<b>Well Name:</b> BLUE CHIP 14 FEDERAL COM	<b>Well Location:</b> T21S / R32E / SEC 11 / SWSE / 32.4885821 / -103.6434103	<b>County or Parish/State:</b> LEA / NM
<b>Well Number:</b> 704H	<b>Type of Well:</b> OIL WELL	<b>Allottee or Tribe Name:</b>
<b>Lease Number:</b> NMNM14155	<b>Unit or CA Name:</b>	<b>Unit or CA Number:</b>
<b>US Well Number:</b>	<b>Operator:</b> MATADOR PRODUCTION COMPANY

**Notice of Intent**

**Type of Action:** APD Change

**Procedure Description:** BLM Bond #NMB001079 Surety Bond # RLB0015172 Matador requests the option to amend the well design of the Blue Chip 14 Fed Com #704H and make the following changes to the current APD: Option A: As permitted 5-string design. No changes from original permit. Option B: 4-string design per figure D in R-111-Q. Will drop intermediate-2 string, if hole conditions allow. - If significant losses are observed while drilling the 12.25" intermediate section, proceed with Option C. Option C: 4-string design per figure E in R-111-Q. Will drop intermediate 3 string, if hole conditions allow. - Option to drill production hole size of 7-7/8". - Option to drill production hole size of 6-3/4". - Option to run 7" casing to KOP and 5.

[Figure D] 4 String – Uncemented annulus between 1<sup>st</sup> and 2<sup>nd</sup> Intermediate casing strings

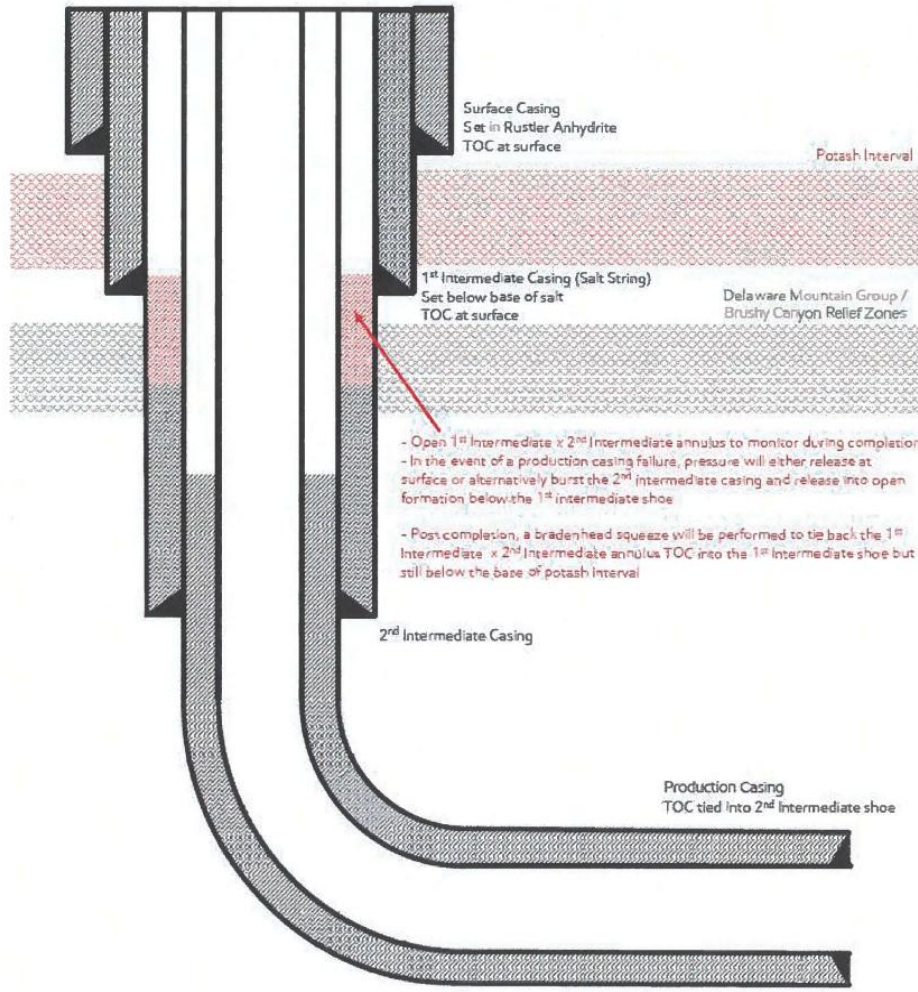
- Option B: 4-string design per figure D in R-111-Q. Will drop intermediate-2 string, if hole conditions allow
- Modify casing set depths as shown on the casing and cementing table. Cement volumes will be adjusted accordingly

- Option D: 4-string design per figure D in R-111-Q. will drop intermediate-2 string, if hole conditions allow.
- Modify casing set depths as shown on the casing and cementing table. Cement volumes will be adjusted accordingly

**Plan B (4-String Design: Open 1<sup>st</sup> Int x 2<sup>nd</sup> Annulus (ICP 2 below Relief Zone))**

3. The 7-5/8 inch 2<sup>nd</sup> intermediate casing shall be set in a competent bed at approximately **12,002 ft.** (11,927 ft. TVD). The minimum required fill of cement behind the 7-5/8 inch intermediate casing is:

- ❖ A monitored open annulus will be incorporated during completion by leaving the 2<sup>nd</sup> Intermediate Casing x 1<sup>st</sup> Intermediate Casing annulus un-cemented and monitored. Operator must follow **all** monitoring requirements listed within R-111-Q. Tieback shall be met within **180 days.**

[Figure E] 4 String – Uncemented Annulus between 2<sup>nd</sup> Intermediate and Production Casing Strings

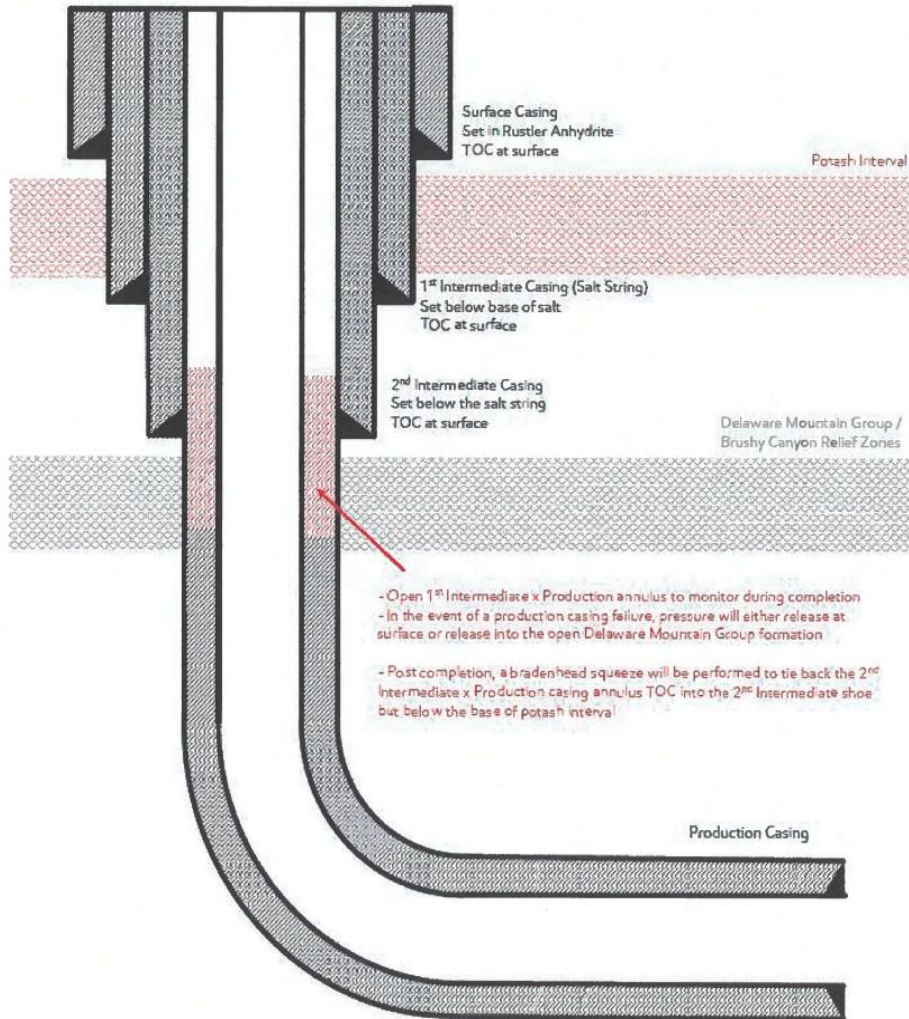
- Option C: 4-string design per figure E in R-111-Q. Will drop intermediate-3 string, if hole conditions allow.
- Option to drill production hole size of 7-7/8"
- Option to drill production hole size of 6-3/4"
- Modify casing set depths as shown on the casing and cementing table. Cement volumes will be adjusted accordingly

**Plan C (4-String Design: Open 2<sup>nd</sup> Int x Production Casing (ICP 2 above Relief Zone))**

- ❖ Operator has proposed an open annulus completion in R-111-Q. Operator shall provide a method of verification pre-completion top of cement. **Submit results to the BLM.**

- ❖ **Operator must verify top of cement per R-111-Q requirements.** Submit results to the BLM. If cement does not circulate, contact the appropriate BLM office. If cement does not tie-back at least 500 ft. into the previous casing shoe, the appropriate BLM office shall be notified.
